SUBJECT: Transmittal of Revised Responses to AP1000 DSER Open Items

AP1000 Design Certification Review
Draft Safety Evaluation Report Open Item Non-Proprietary Responses

DSER Open Item Number: 3.8.2.1-1 Revision 2

DSER Open Item Number: 19.1.10.1-5 (Response Revision 2)

Figure 19.1.10.1-5e-6- 2: CMT Level for 2-inch Hot Break Leg PRA Case - NOTRUMP

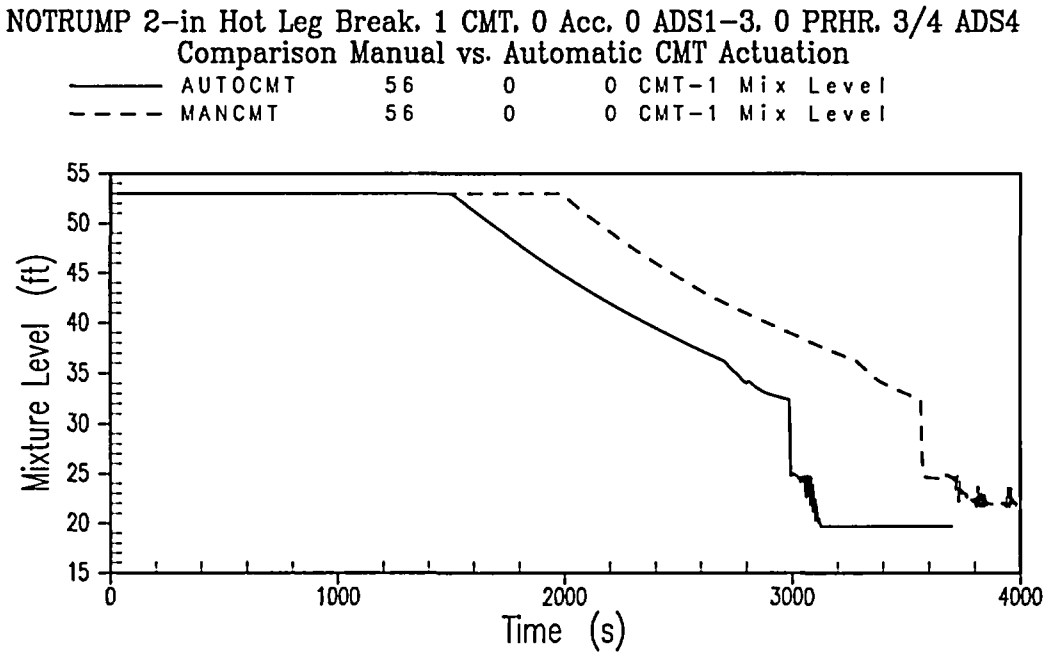
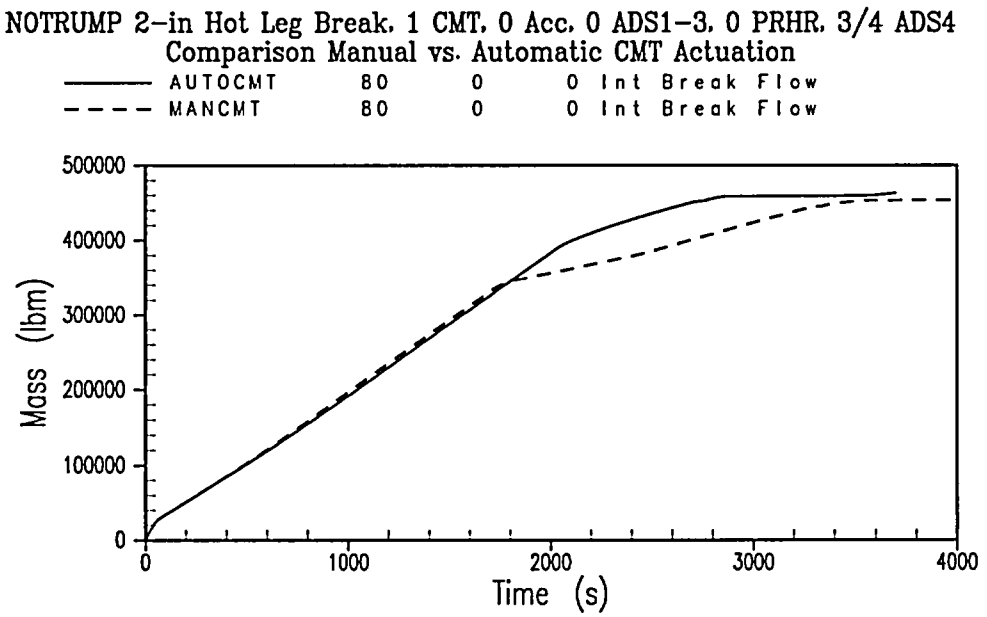
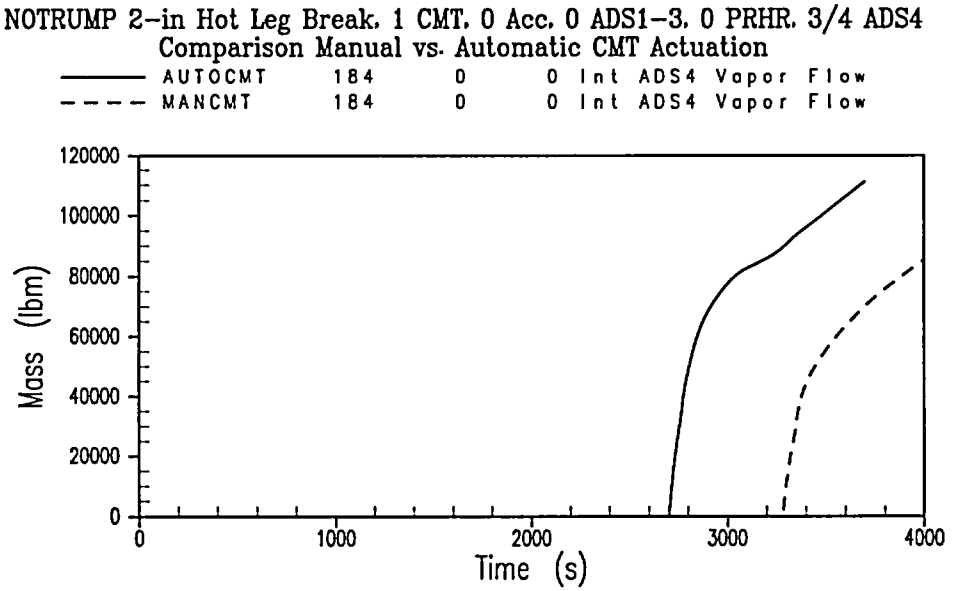
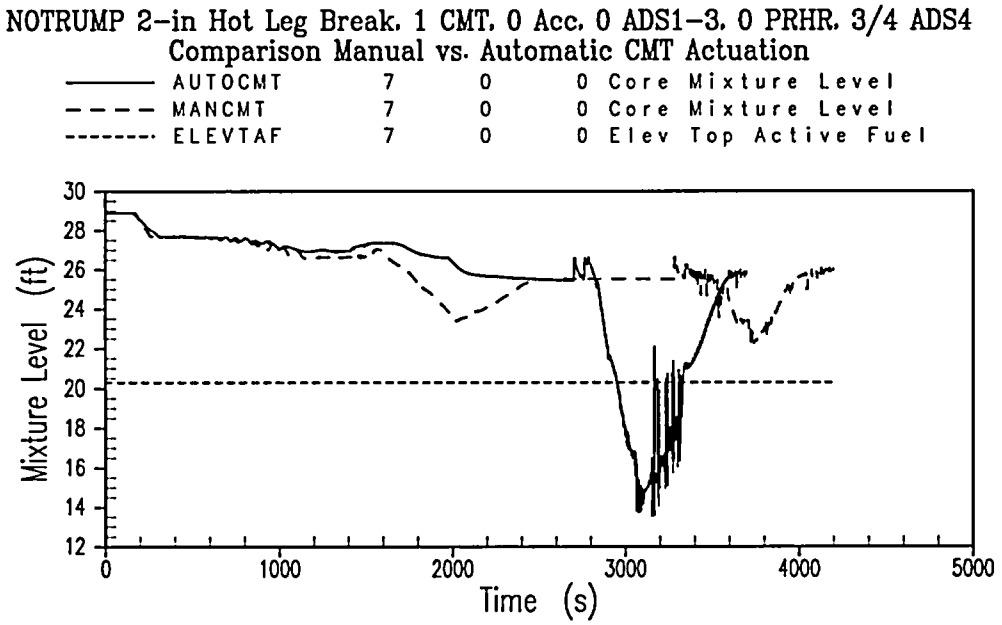
An analysis using MAAP4 was performed to demonstrate that a 30 minute delay in CMT injection is acceptable following a SBLOCA and multiple failures. The consequences were determined to be bounded by a MAAP4 analysis with automatic actuation. Westinghouse asserted that since this is not a limiting case a NOTRUMP analysis is not required. For the manual CMT case there is no ECCS for 2000 seconds after the break. For the automatic actuation case, CMT injection occurs about 200 seconds after the break. How can the automatic CMT actuation injection case be worse than the manual CMT actuation case which has a longer delay time?

(e) The case in question (2 inch break, 1 CMT, 0 ACC, 0 ADS1-3, 0 PRHR, ¾ ADS4) has now been performed using NOTRUMP, for automatic CMT actuation and for manual CMT actuation. Comparison plots of these two NOTRUMP cases are shown in Figures 19.1.10.1-5e-1 through 19.1.10.1-5e-6. For the automatic CMT case the CMT draindown starts earlier and leads to earlier actuation of ADS4. For the automatic case the CMT

recirculates from the early part of the event and its water inventory becomes heated before draindown begins, whereas for the manual case CMT draindown occurs shortly after CMT actuation and therefore is injecting subcooled liquid during its draindown. When ADS4 actuation occurs in the automatic case the vessel inventory and CMT injection are near saturation and the rapid depressurization results in sufficient voiding to cause the vessel mixture level to fall into the core region before it recovers as a result of IRWST injection. In the manual case the CMT injection just prior to and following ADS4 actuation is still highly subcooled so the depressurization causes less voiding and the vessel mixture remains in the upper plenum region during the ADS4 to IRWST transition.

These NOTRUMP results confirm the behavior seen in the previous MAAP4 analyses.

Figure A3.5-1

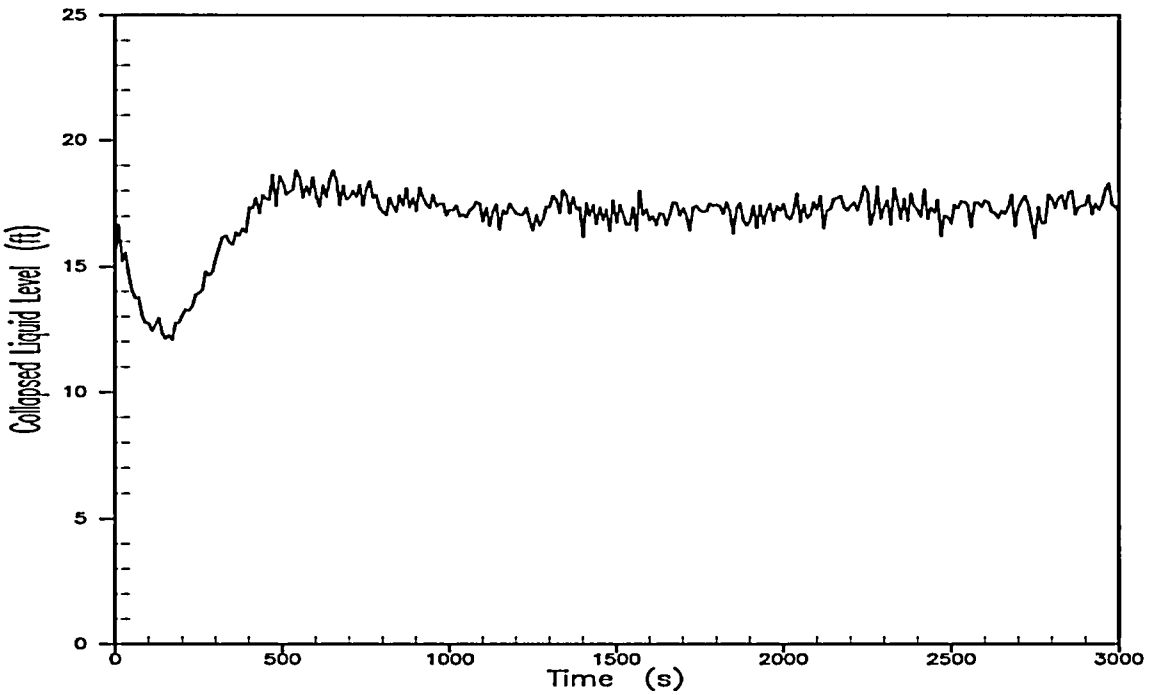
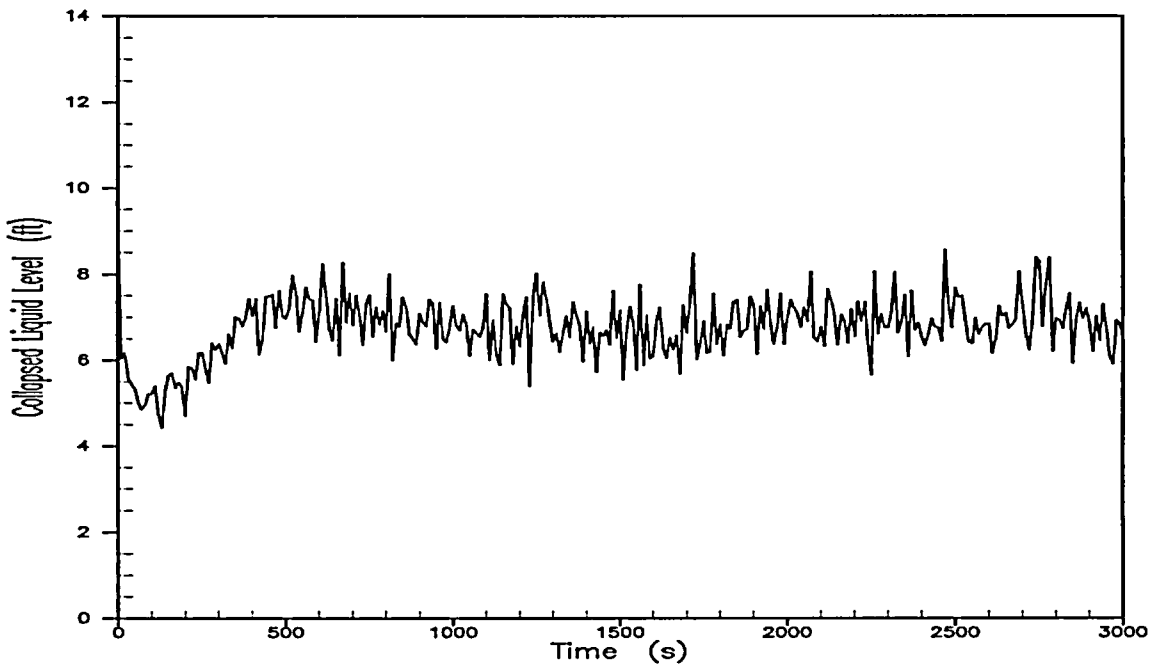
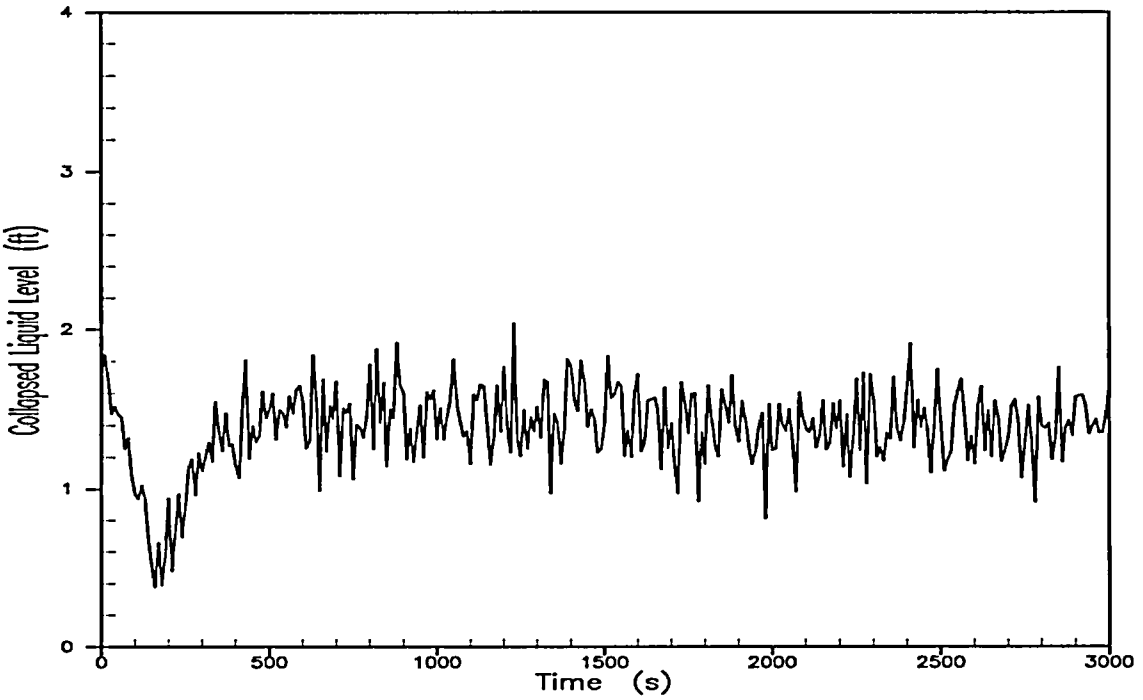
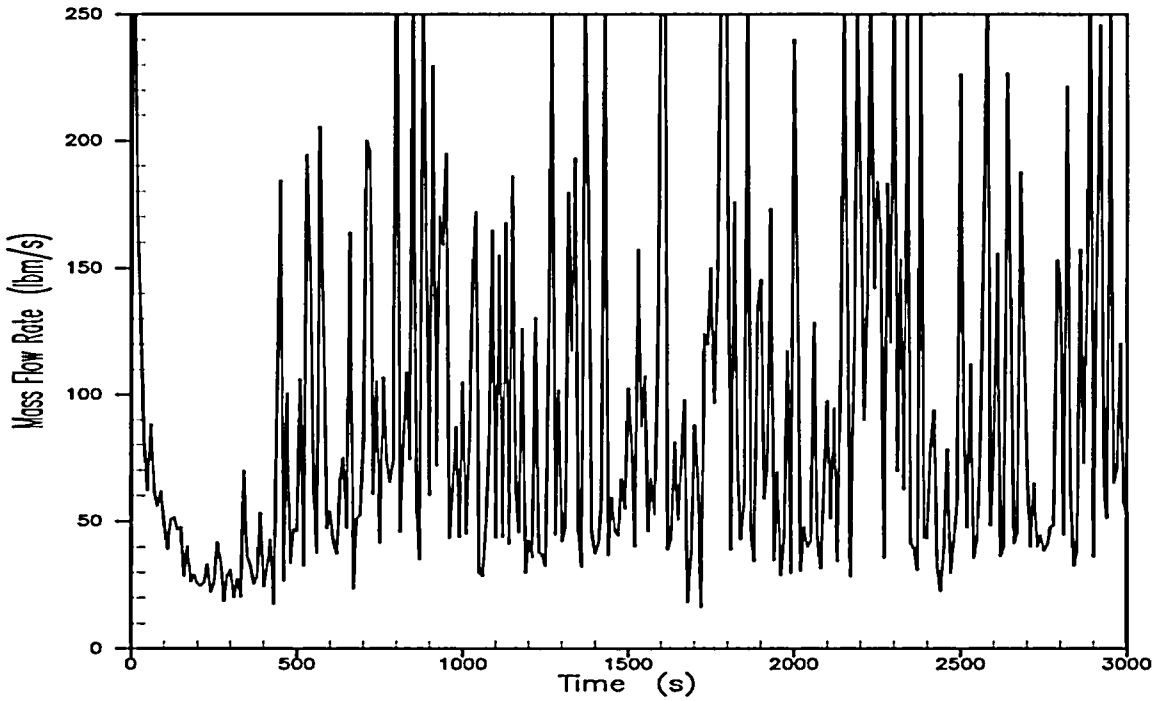
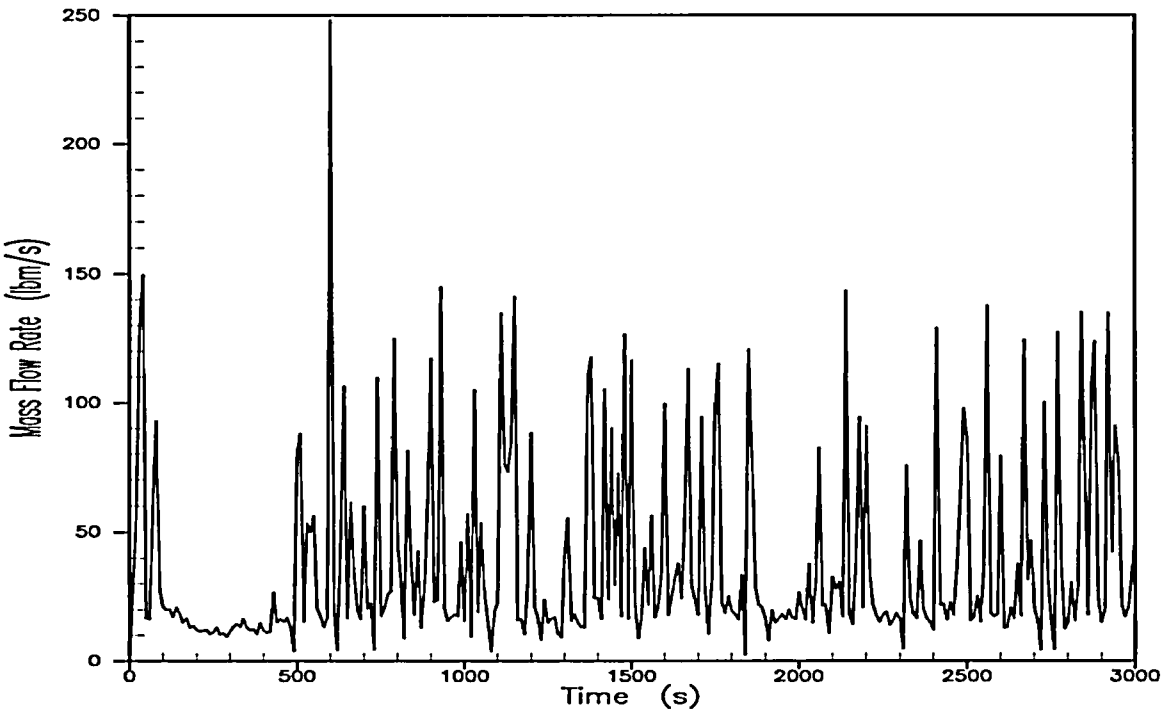
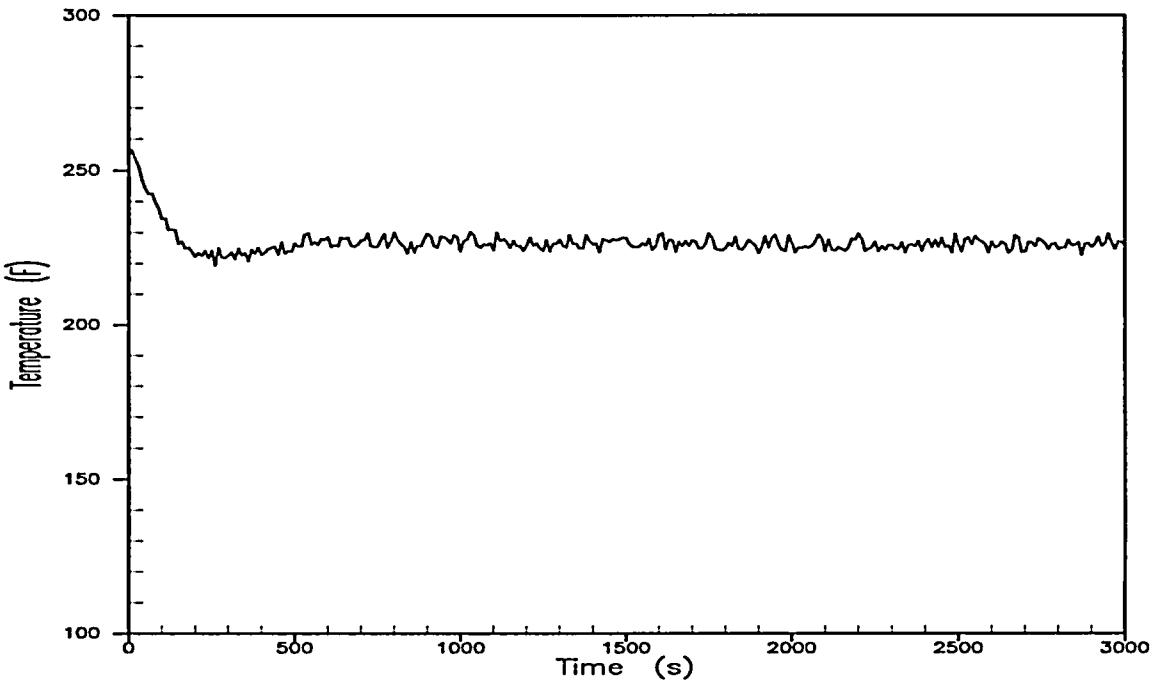
(a) Additional justification is needed for long-term cooling analyses for which the initial and boundary conditions were obtained from analyses using MAAP4 for input into WCOBRA/TRAC (RAI 720.013):

This issue remains open. In the revised response to RAI 720.013, Westinghouse performed long term cooling analyses for bounding conditions in the PRA. (Case F DEDVI, 1 CMT, 1 recirc line, 3/4 ADS4 and CI) and (Case G DEDVI, 1 CMT, 1 recirc line, 4/4 ADS4 and CI failure). The WCOBRA/TRAC code was used for LTC calculations with input conditions derived from MAAP4 analyses. As discussed in the DSER the staff has not reviewed MAAP4 except for its use in screening studies. These are analyses using minimum equipment sets as discussed in the DSER. The staff believes that only a methodology the staff has reviewed should be utilized. In addition, as a result of staff and ACRS questions, the WCOBRA/TRAC long term cooling model has been changed. The staff believes that the revised model should be used in these bounding calculations.

(a) The long term cooling success criteria analysis case and the thermal hydraulic uncertainity cases F and G have now been performed using the revised WCOBRA/TRAC model and using input conditions from WGOTHIC. The revised cases replace the previous cases as shown below in the revision to PRA Appendix A.

~~into the downcomer through the DVI break supplements the IRWST injection. As this flow path becomes established, t~~The levels in the downcomer (Figure A3.5-1), the reactor core (Figure A3.5-2), and the upper plenum (Figure A3.5-8) are sufficient to maintain core cooling~~increase. The effect of this injection flow increase is also seen in Figures A3.5-3 and A3.5-4, which show a void fraction decrease in the upper half of the core~~.

The three available ADS Stage 4 valves provide enough venting capacity that adequate depressurization capability exists to achieve successful performance of the passive safety systems (Figures A3.5-9 and A3.5-10). The fuel remains covered throughout the transient, and adequate core cooling is provided to remove the decay heat. The hot rod cladding temperature at the top of the core is slightly above saturation temperature (Figure A3.5-12) throughout the transient.
